SB-GA8-2011-82

Service Bulletin

GA200-772011-13 CHT Probe Assembly is superseded by a Standard Alcor 86251 CHT Probe – (Bayonet Type.)

Figure 1: Location for CHT Probe Installation

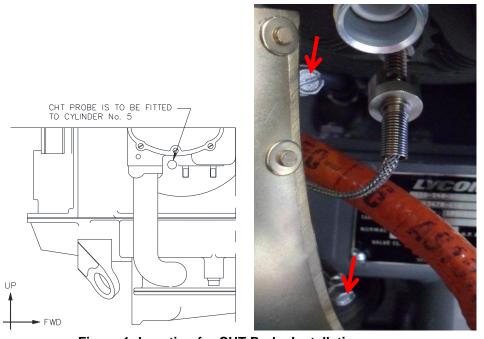
REMOVAL OF THE CLAMP OF THE PRE SB 82 PROBE

1. Loosen the clamps screws as shown in the figure 1.

Keep the adapter connected to the engine while removing the CHT probe

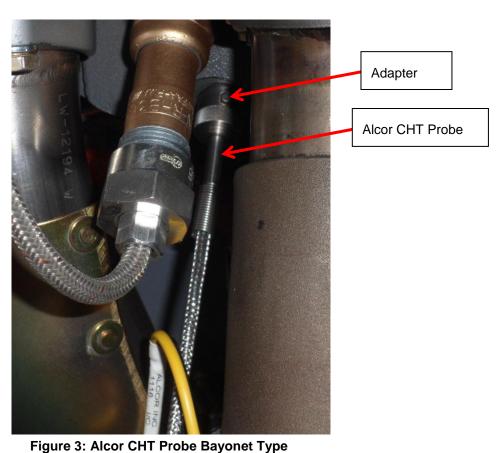
3. Install the Alcor 86251 CHT Probe Bayonet Type as shown in Figure 3.

Allow enough slack in probe lead to provide a finger-size loop to minimize strain on wire and secure remainder of lead to engine/airframe away from exhaust pipe.
